October 16, 2024

RE: Revised Overfill Management Plan
Garland County Cedar Glades Class 4 Landfill
Permit# 0300-S4; AFIN 26-00405
Terracon Project No. 35247209

FIGURE 3

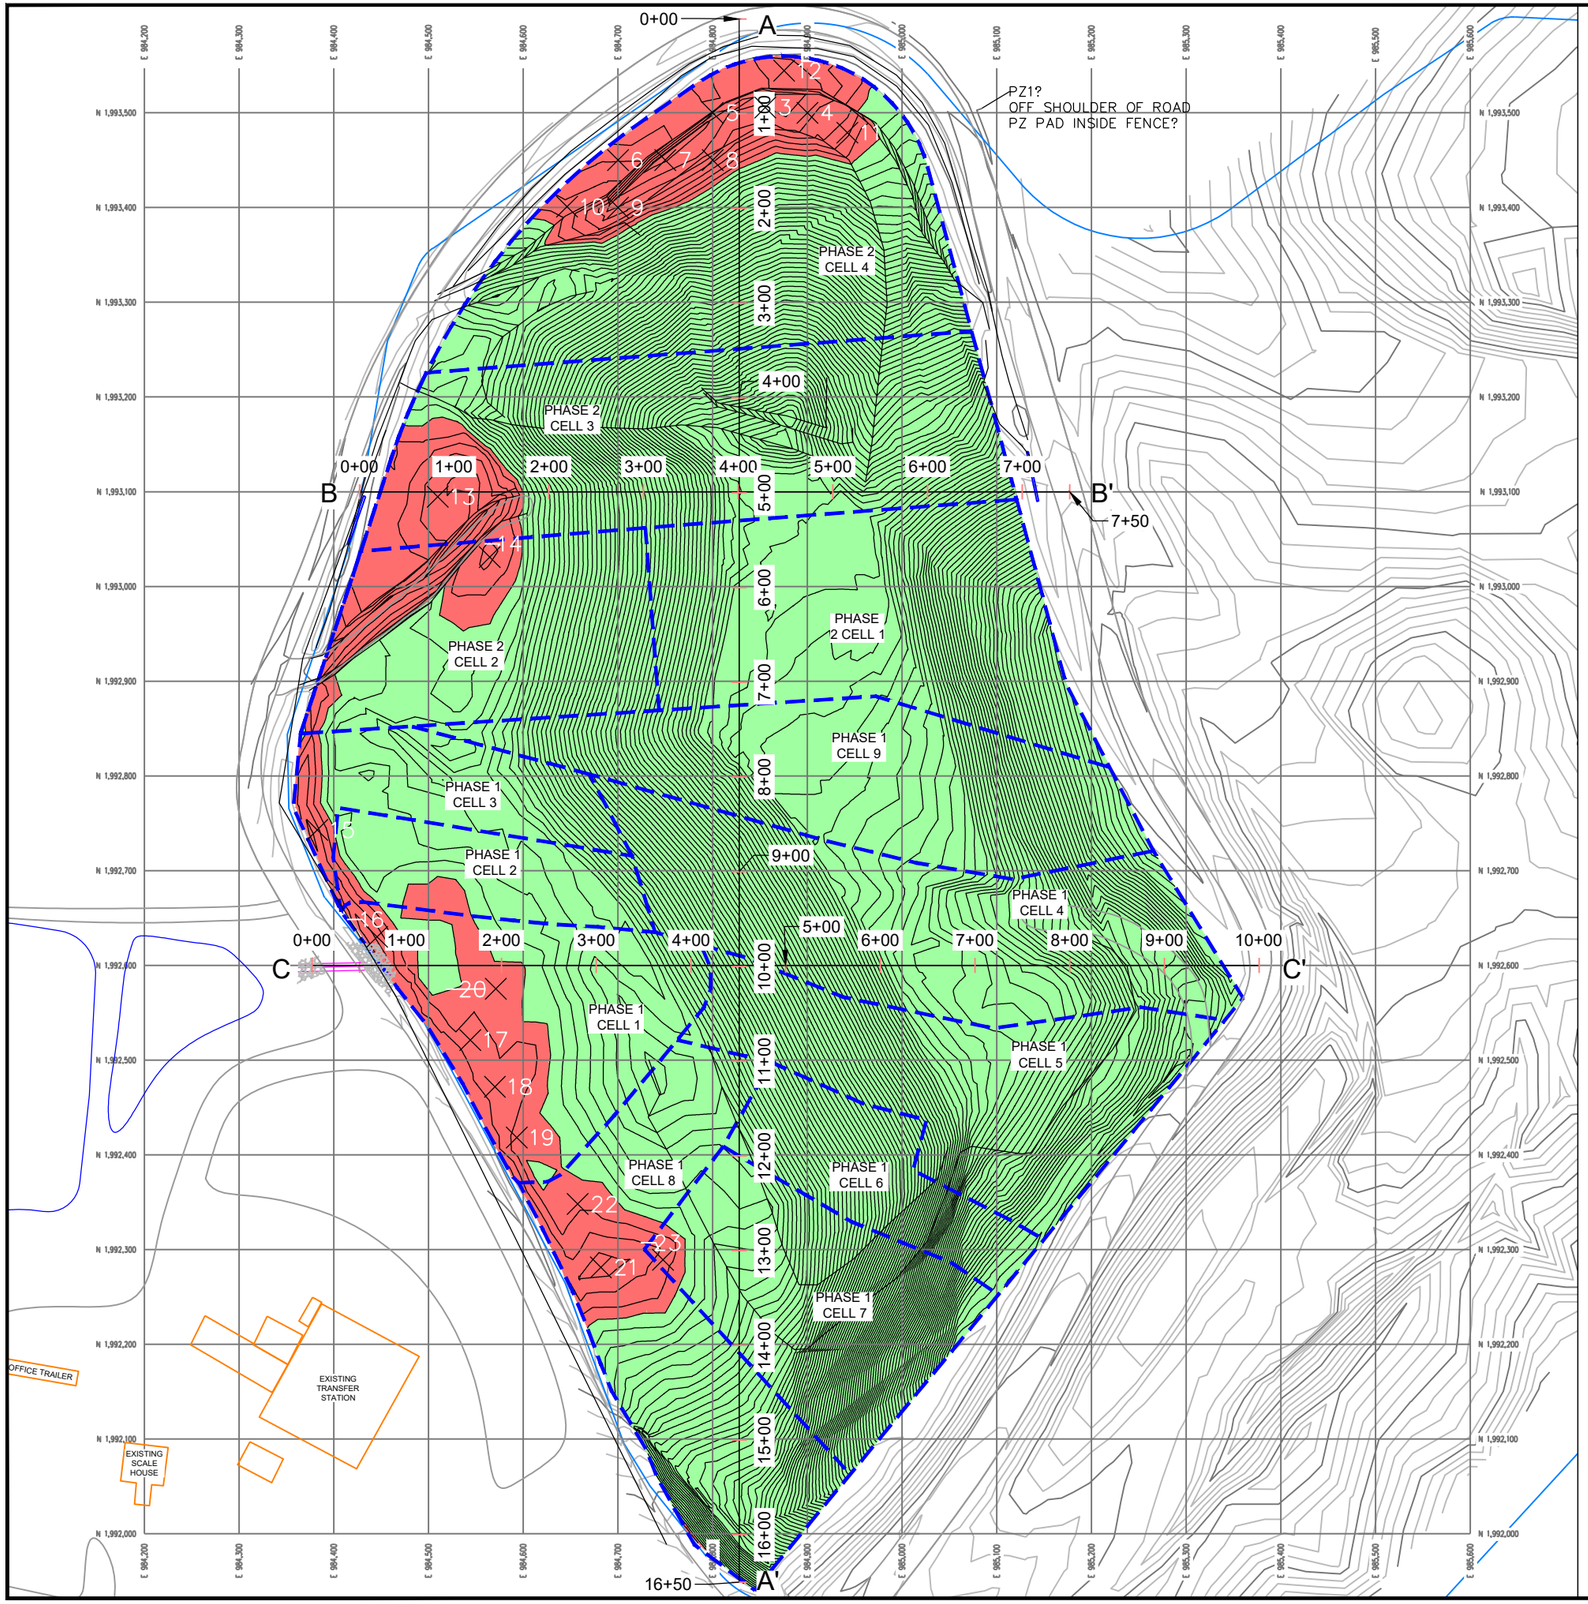
As shown on the enclosed drawing, the lateral extent of areas above final waste grades involve approximately 118,000 sq. ft. of area on the northern and western sides of the active landfill.

Waste overfill shown along the north side of Phase 2, Cell 4, illustrated in attached Figure 3 and in cross section A-A' on attached Figure 4, will be removed and the area re-graded to keep the waste and interim cover at or below the final waste grades. For removal of wastes and soils that are currently present above the final waste grades, confirmatory survey shots will be taken after removal to demonstrate the areas are then within the final waste grades. These activities are planned to be completed within 30 days of the DEQ approval of this OFMP. The soil only overfill areas along the west slope will remain until the area is regraded and closed with a low permeability cover system during Summer 2025 per the schedule below.

ALIGNMENT B-B'

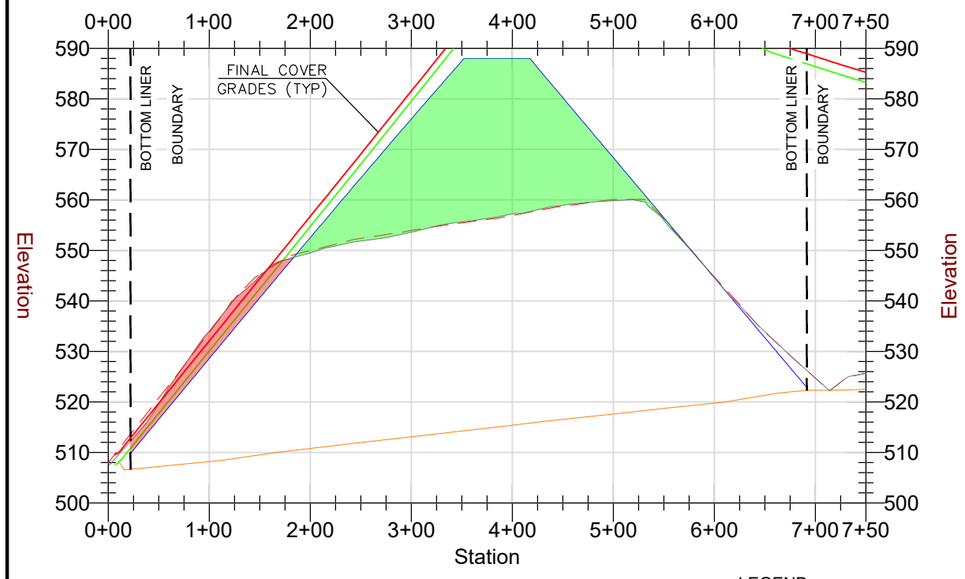
Roadway materials and supporting soil have also been placed above the finished final waste grades slope along the western portions of Phase 2, Cell 2 and Phase 2, Cell 3. Fill from the roadway construction is visible on cross section B-B' on attached Figure 4. If portions of overfill in this area are not associated with the ingress/egress operational road and are not in place to support the access road, they will also be removed to within the final waste grades within 30 days of the DEQ approval of this OFMP.
